Title: PHILCO 46-480 SCHEMATIC

Size: E	Date: 2025-02-16	Rev: 1
KiCad E.D.A. 8.0.8		Id: 1/1

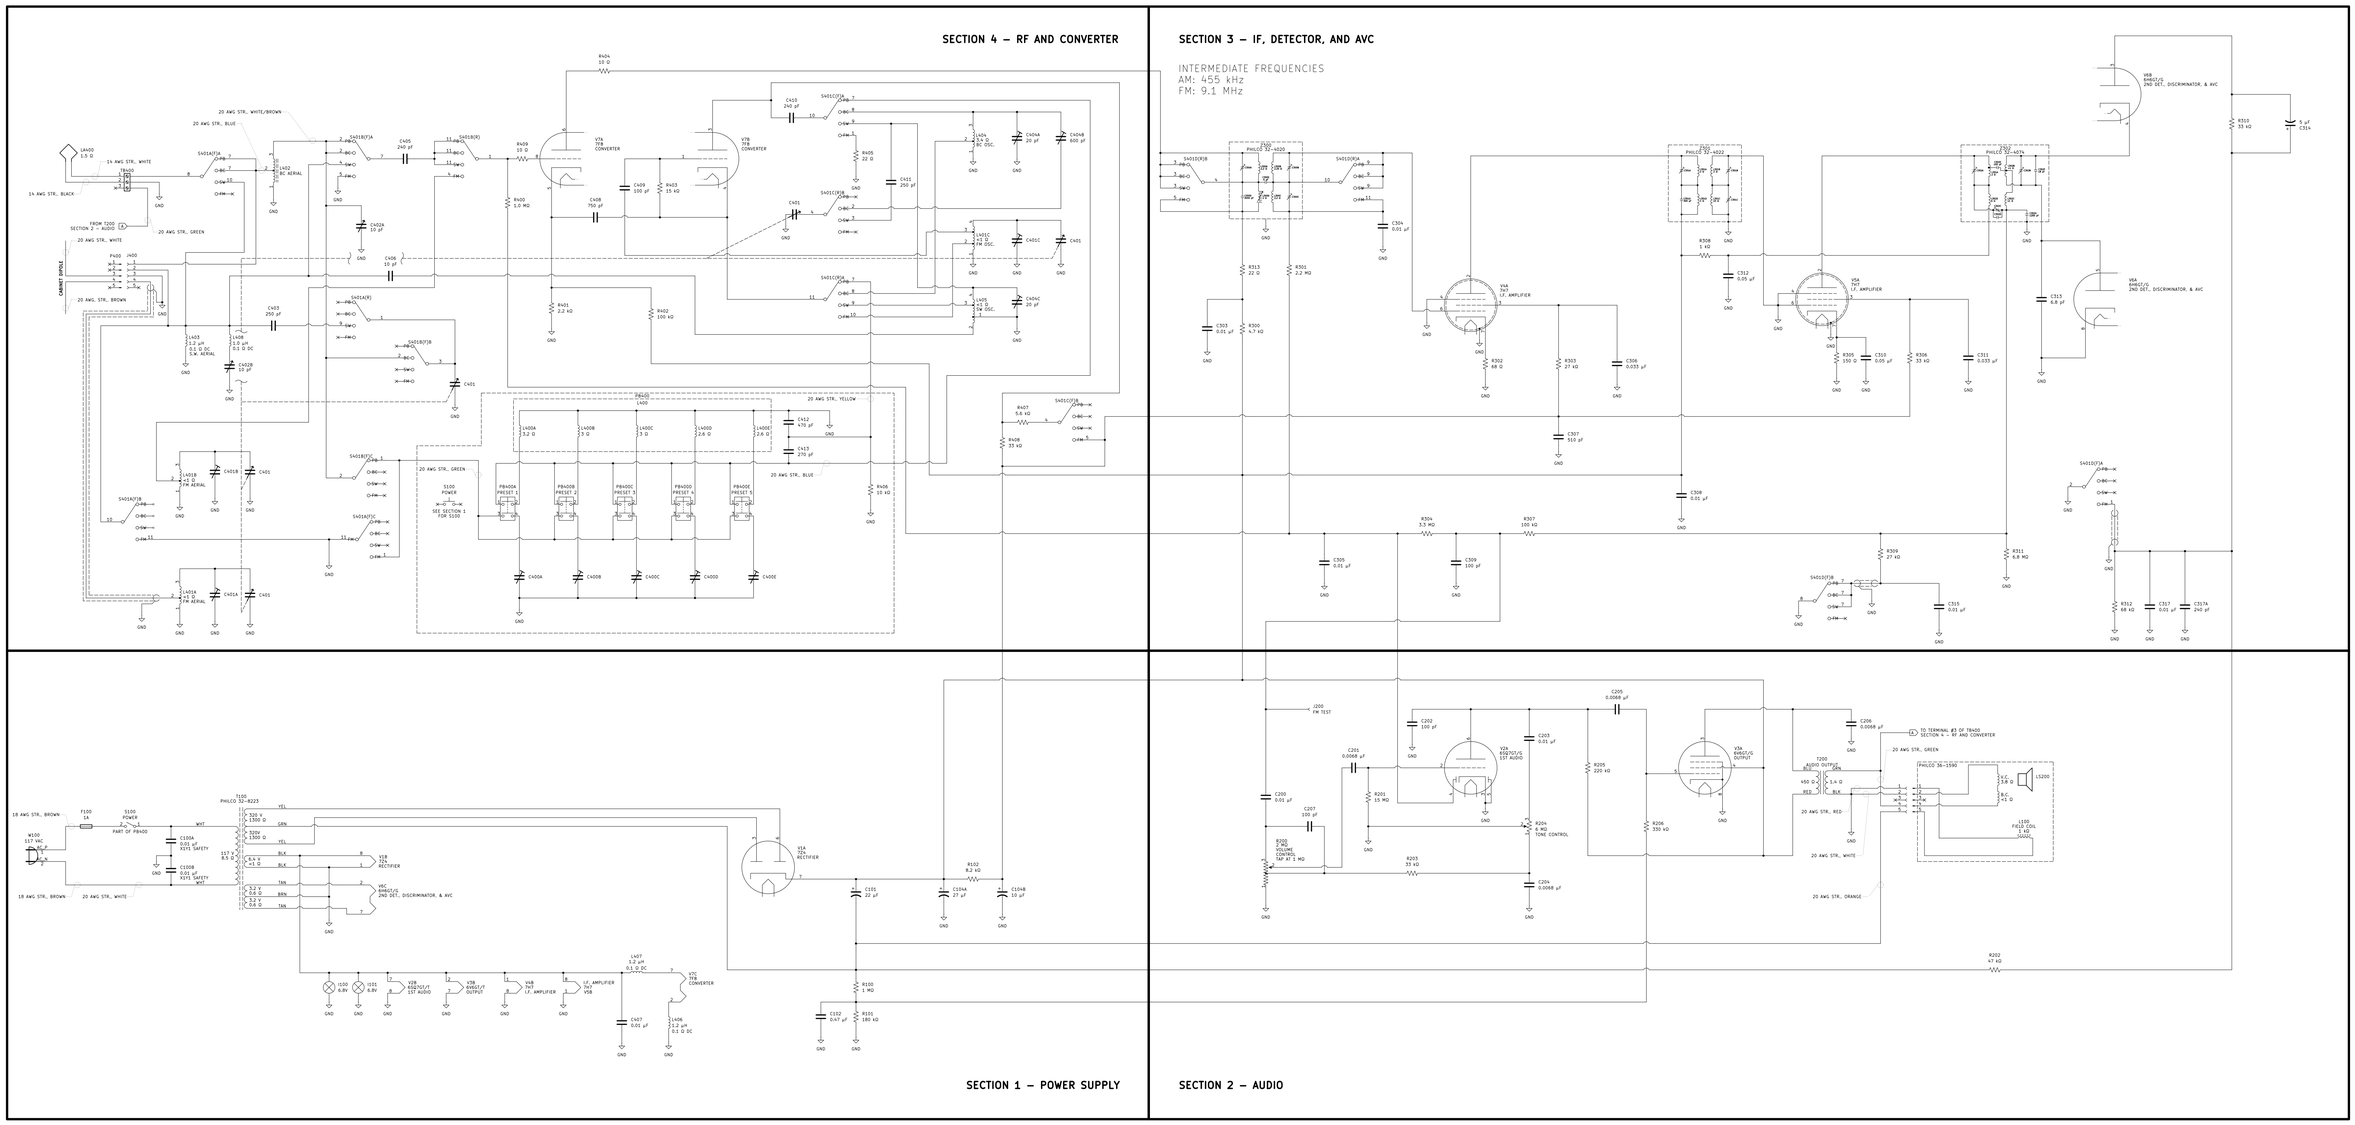
REV 1 CHANGES
* W100 REPLACED BY POLARIZED PLUG.
* S100 MOVED FROM NEUTRAL TO HOT SIDE OF 117 VAC CIRCUIT.
* S100 MOVED FROM NEUTRAL TO LINE SIDE OF PRIMARY 117 VAC CIRCUIT.
* C316A RENAMED TO C317A; IT IS IN PARALLEL TO C317. AND C316 WAS REMOVED DURING REDRAWING.
* C100A & C100B MOVED DOWNSTREAM OF S100, SO AS TO BE DE-ENERGIZED WHEN RADIO POWERED OFF.
* C100A & C100B UPGRADED TO X1Y1 RATED SAFETY CAPACITORS.
* C101 CHANGED FROM 25 µF TO 22 µF.
* C102 CHANGED FROM 0.5 µF TO 0.47 µF.
* C104A CHANGED FROM 25 µF TO 27 µF.
* C201, C204, C205, C208 CHANGED FROM 0.006 µF TO 0.0068 µF.
* C306, C311 CHANGED FROM 0.01 µF TO 0.033 µF.
* C402 CHANGED FROM 250 µF TO 240 µF.
* C403 CHANGED FROM 250 µF TO 200 µF.
* C412 CHANGED FROM 485 µF TO 470 µF.
* C413 CHANGED FROM 285 µF TO 270 µF.
